URBAN DESIGN EVIDENCE STATEMENT

LANCEFIELD ROAD PSP &
APPLICATION FOR PLANNING PERMIT P18855

PREPARED BY ANDREW TAMME FOR
WINCITY DEVELOPMENT PTY LTD
14 AUGUST 2017

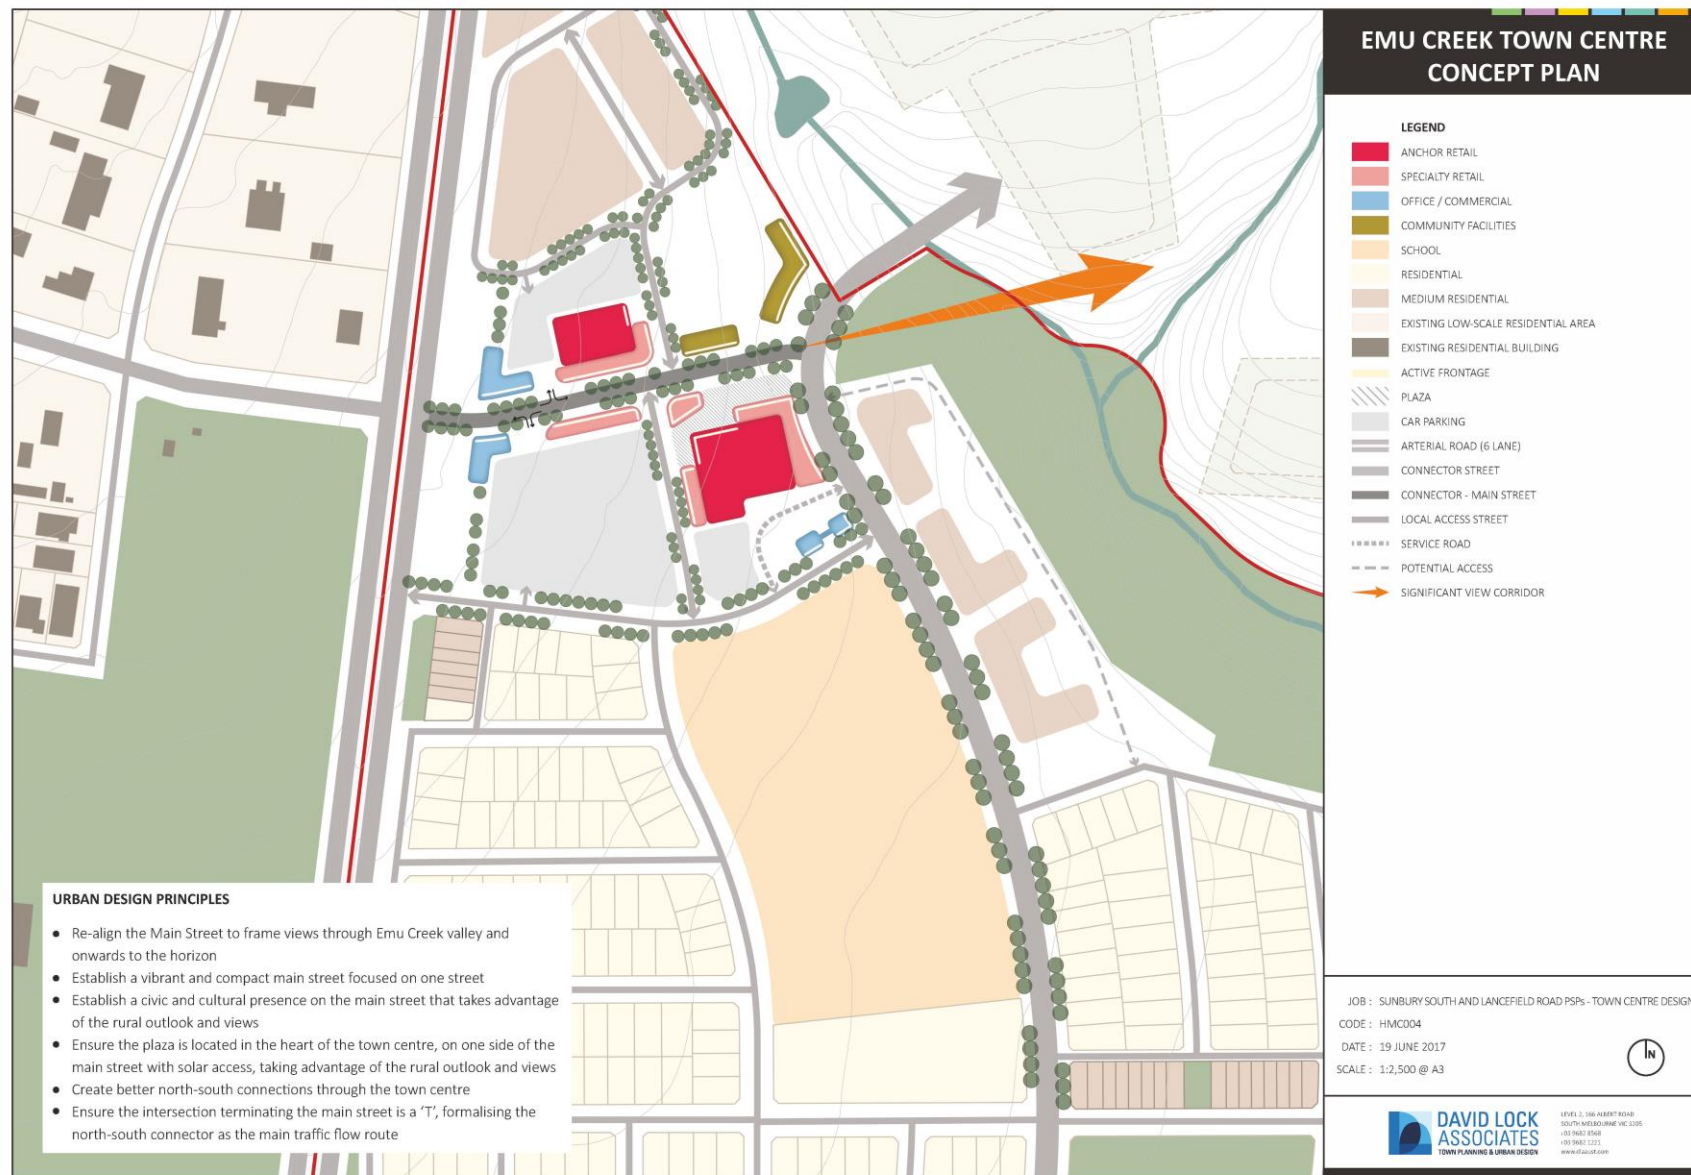
It is my opinion that the Emu Creek Local Town Centre, created by David Lock and associates (DLA), reference: HMC004, 19th June 2017 be adopted, with the following changes;

1. Reduce setbacks of built form elements from Lancefield Road, as there appears to be no justification for such a large setback.
2. Remove the local access street between the Anchor Retail and Main Southern Carpark, and replace with a notation stating, "potential access point".
3. Revise the location of the Community Site as per the current Wincity Application, to be co located with the Government School Site.
4. Introduce Wetland WL-15 to accord with size and location as per "Potentially Developable Land – Land not serviced by Development Service Scheme. (Appendix A)
5. The inclusion of a shared path within the road reserve adjoining the south side of the town centre.

Appendix A – Revised Town Centre Plan

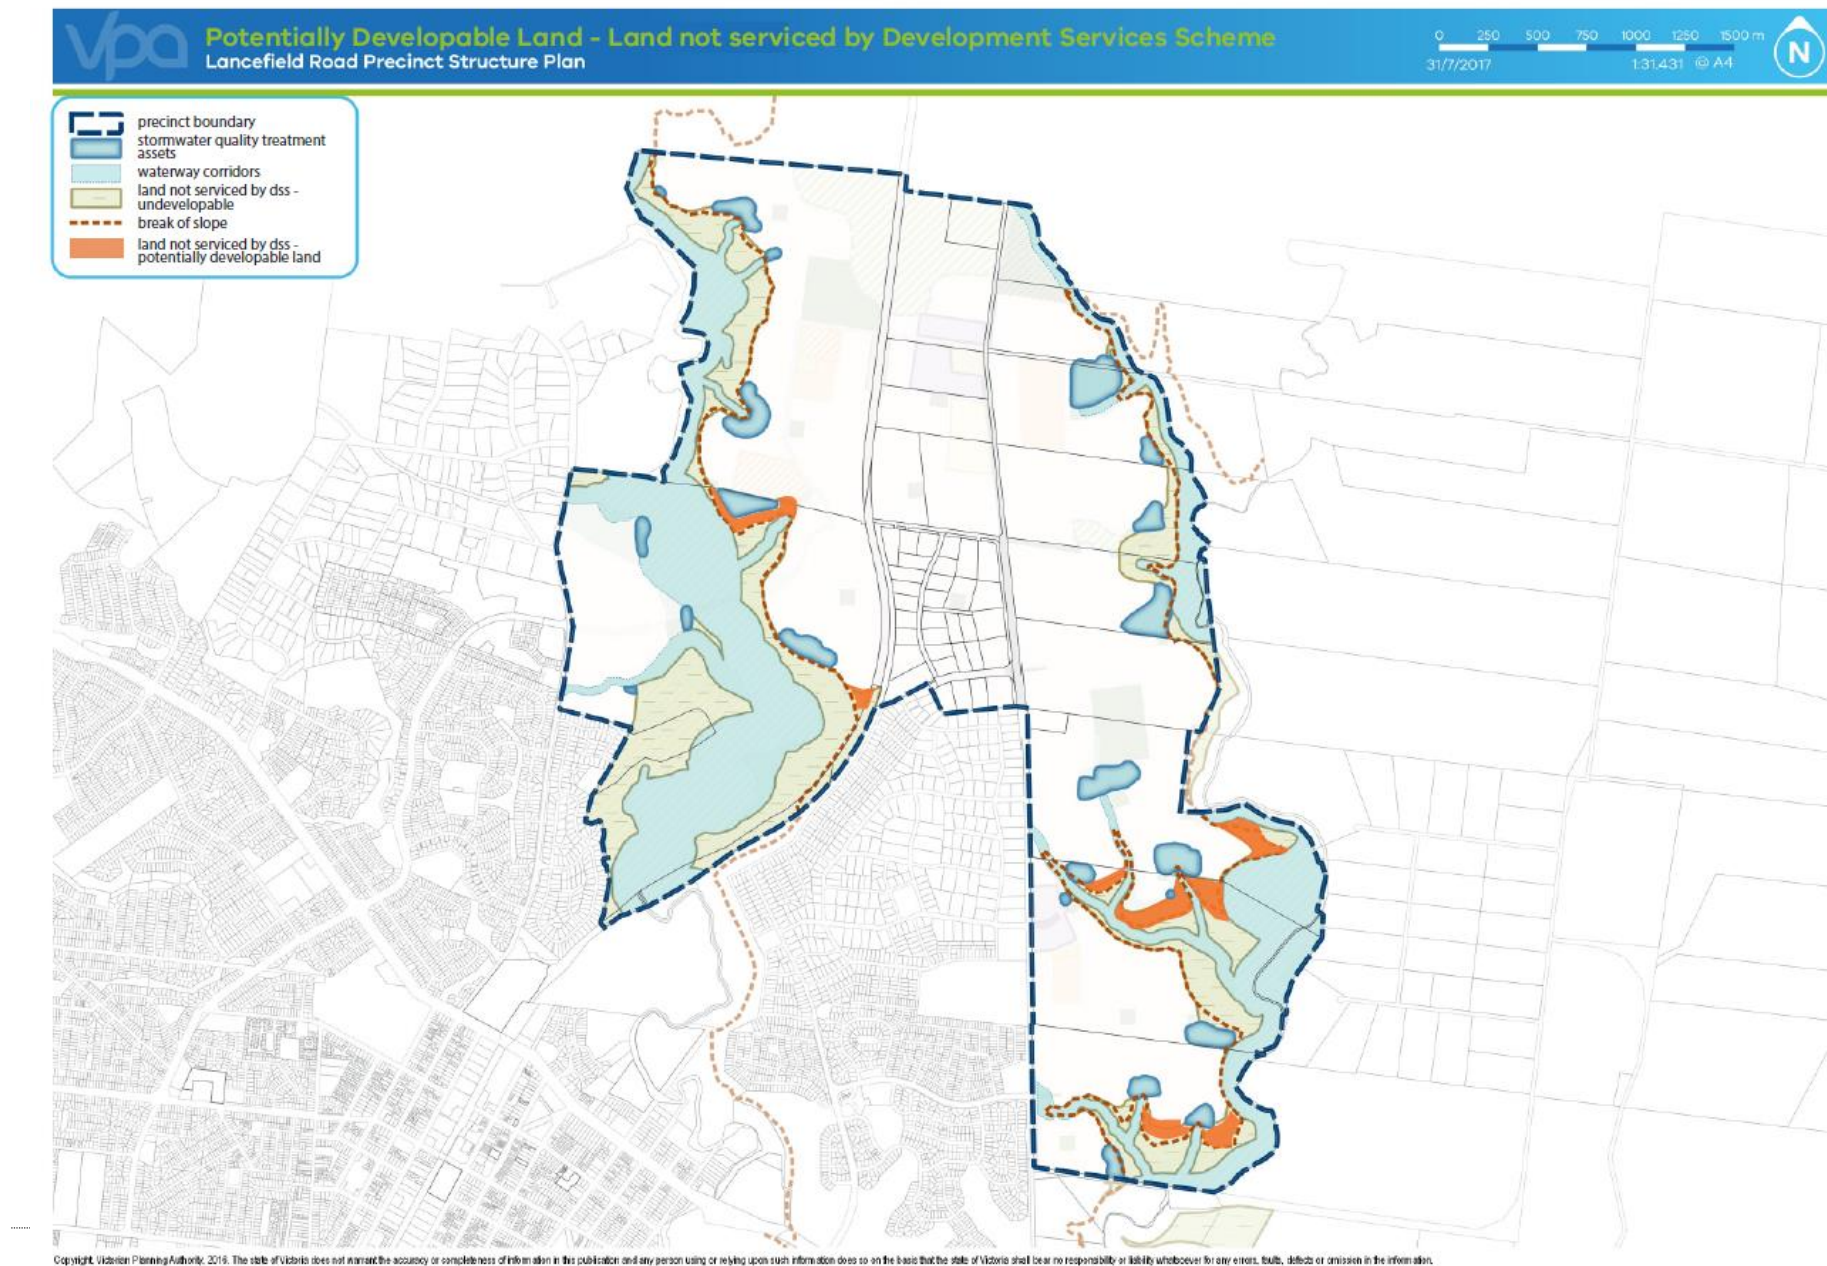
1. Reduce setbacks of built form elements from Lancefield Road, as there appears to be no justification for such a large setback.
2. Remove the local access street between the Anchor Retail and Main Southern Carpark, and replace with a notation stating, “potential access point”.
3. Revise the location of the Community Site as per the current Wincity Application, to be co located with the Government School Site.
4. Introduce Wetland WL-15 to accord with size and location as per “Potentially Developable Land – Land not serviced by Development Service Scheme. (Appendix A)
5. The inclusion of a shared path within the road reserve adjoining the south side of the town centre.

Appendix B – Potentially Developable Land – 31 July 2017

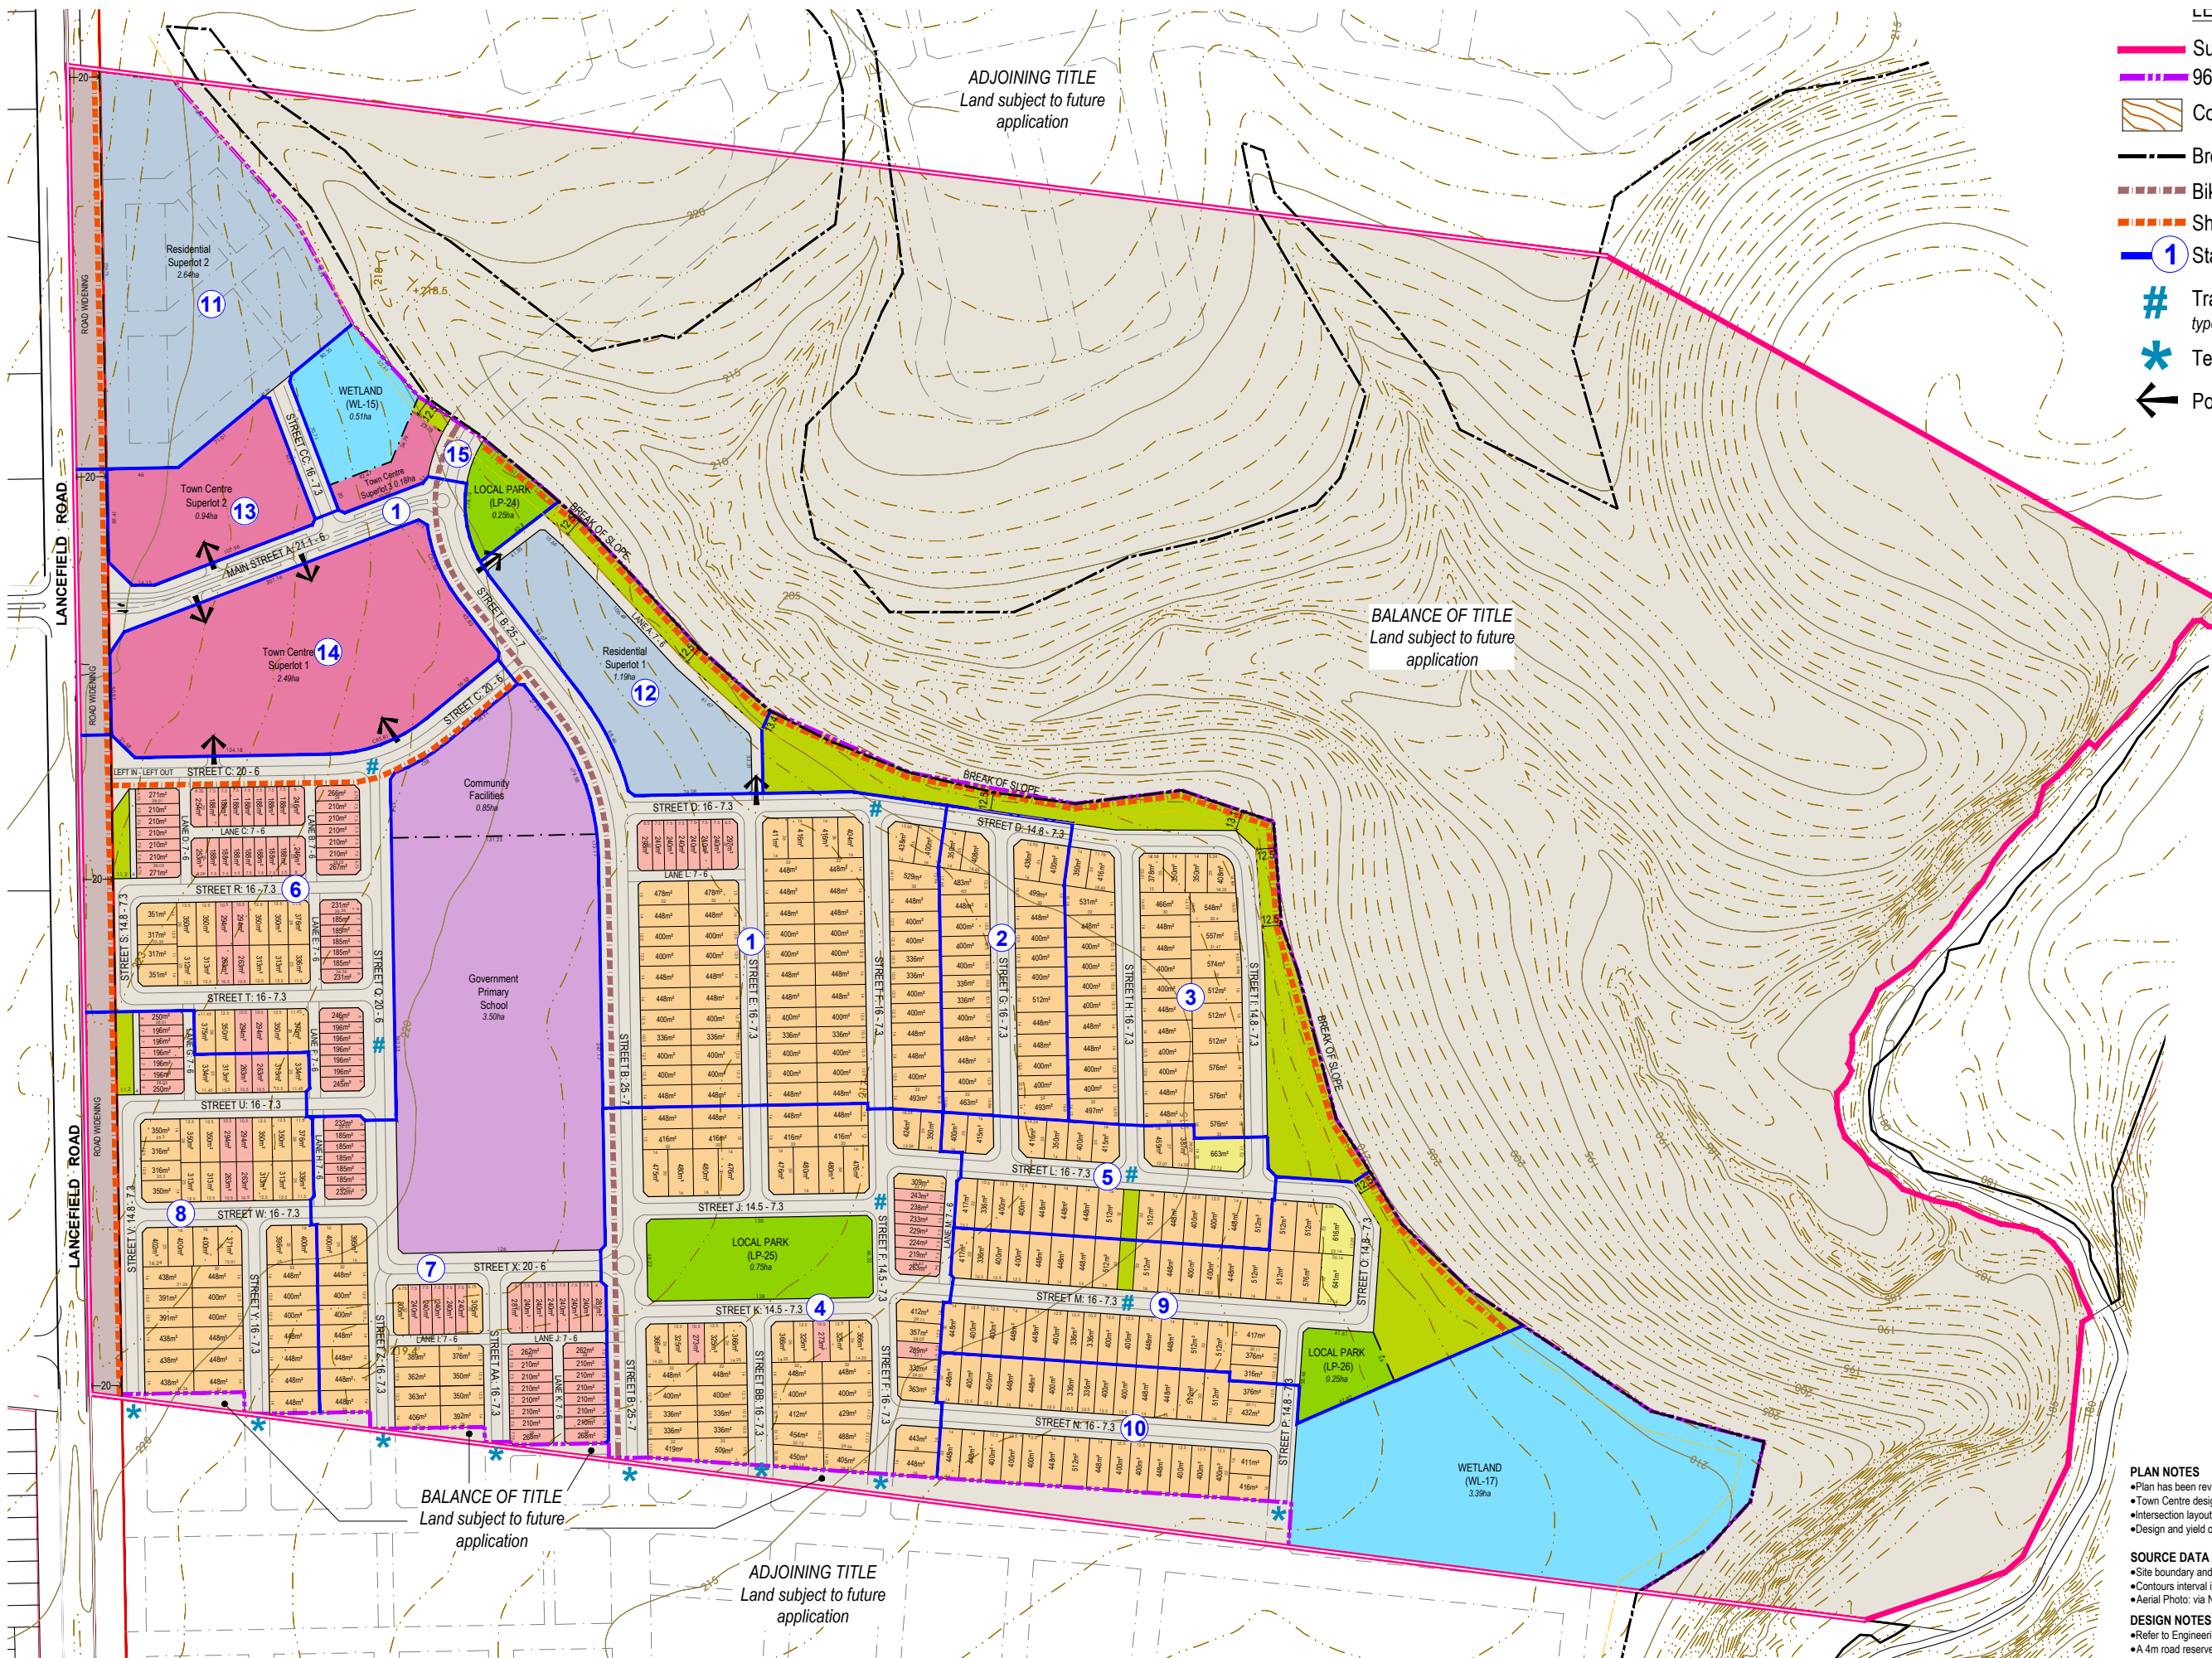
Item ID	Changes to the application	Expert Response
RFI 1	Break of Slope issued	Noted.
RFI 2	Ensure Subdivision Plans are annotated with the dimension between the break of slope and the nearest lot boundary along the western edge of the residential subdivision as necessary to illustrate how the subdivision delivers the setback outcomes sought by the PSP.	The Subdivision Masterplan includes setback dimensions from; the break of slope (issued by the VPA on 18 th July 2017) and the nearest lot boundaries along the western interface of residential subdivision within the S96A area. A minimum buffer distance of 12.5m has been achieved to in order to deliver the desired outcomes as shown on the Escarpment Top - Non Visually Sensitive Road Cross Section.
RFI 3	Please note Melbourne Water's submission to Hume C208 and the draft Oldbury Drainage Service Scheme. Please ensure revised submission plans address the draft scheme.	The Subdivision Masterplan has been updated to reflect the land shown on the plan labelled "Potentially Developable Land – Land not serviced by Development Service Scheme" (Appendix A)
